Access Compliance Report

Public Rights-of-Way (Curb Ramps)

Intersection ID: 45705	Main Street: CALDWELL_RIDGE_PY	Cross Street: N/A	Location: NW
ADA ID: 149D031BBE32	Ramp Type: Perp	Initial Pass/Fail: Fail	Overall Compliance: No
		Severity Score: 22.5

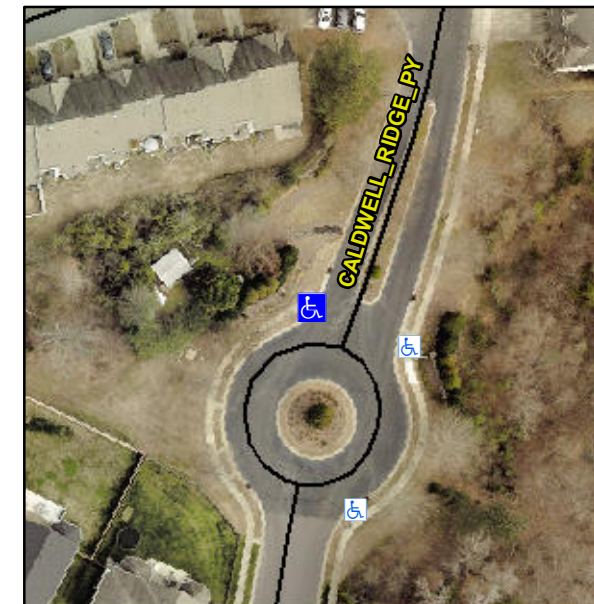
Not Found, R304.5.1, R304.2.2

Compliance	Description	Data	Compliance	Description	Data
N/A	Ramp Length (in)	47.0	No	Ramp Slope (%)	10.6
No	Ramp Width (in)	42.5	Yes	Ramp XSlope (%)	2.7
N/A	Flare Type LT	N/A	N/A	Flare Type RT	N/A
N/A	Flare Slope LT (%)	N/A	N/A	Flare Slope RT (%)	N/A
N/A	Flare Traversable LT?	N/A	N/A	Flare Traversable RT?	N/A
N/A	Landing Length (in)	N/A	N/A	DWS Provided?	N/A
N/A	Landing Width (in)	N/A	N/A	DWS Contrast?	N/A
N/A	Landing Slope (%)	N/A	N/A	DWS Length (in)	N/A
N/A	Landing X Slope (%)	N/A	N/A	DWS Full Width?	N/A
N/A	Landing Curb? (Y/N)	N/A	N/A	DWS Offset (in)	N/A
N/A	Shared Landing?	N/A			
N/A	Gutter Ponding?	N/A	N/A	Gutter Slope (%)	N/A
N/A	Gutter Lip Ht (in)	N/A	N/A	Gutter X Slope (%)	N/A
N/A	Painted X Walk1?	No	N/A	Painted X Walk2?	N/A
	X Walk 1 Direction	To NE		X Walk 2 Direction	N/A
N/A	X Walk 1 Width (in)	N/A	N/A	X Walk 2 Width (in)	N/A
	X Walk 1 Slope (%)	2.1		X Walk 2 Slope (%)	N/A
	X Walk 1 X Slope (%)	3.4		X Walk 2 X Slope (%)	N/A

Remove & Replace Entire Ramp.
